Log #: TS-0006

Inadvertent System Reset

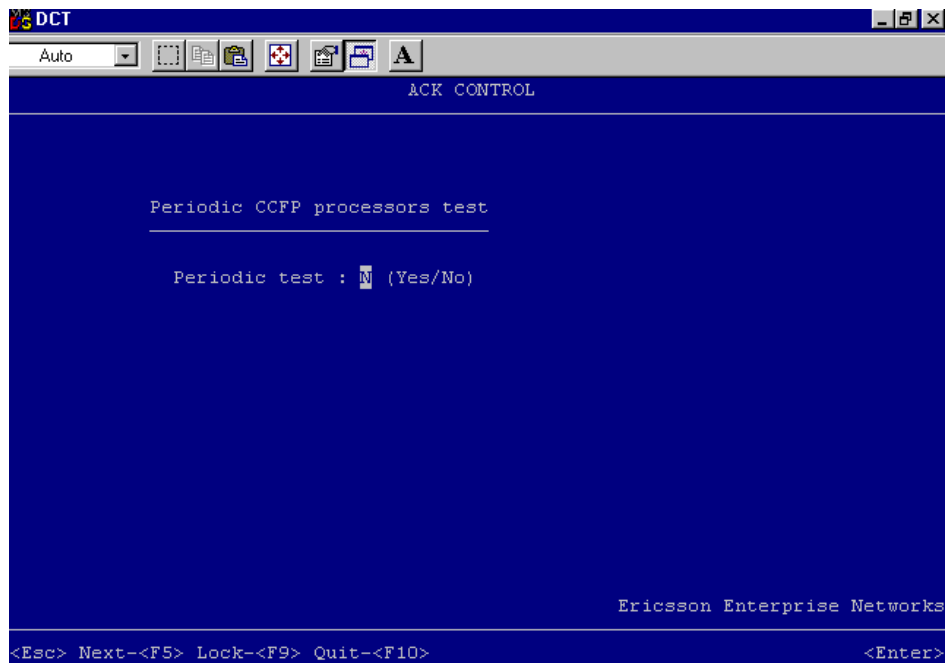
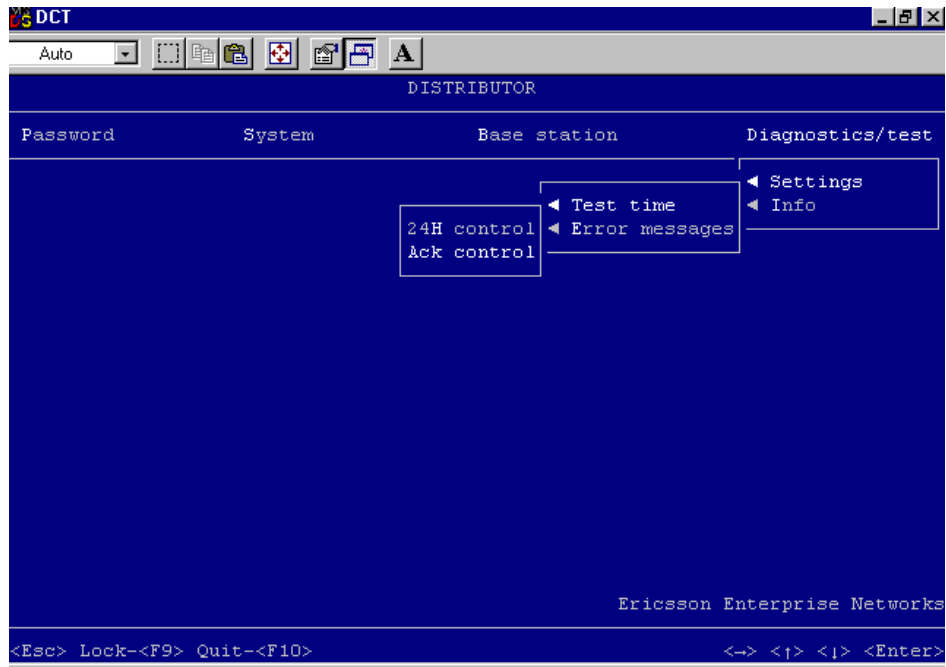
When possible the CPU Firmware should be replaced with a corrected revision and the system should be re-initialized. A temporary fix is to turn off the periodic Acknowledgement test. Each CPU test may be disabled using the CSM.

In the CSM Distributor Menu

Select Diagnostics/tests

Ack control

N (Yes/No)
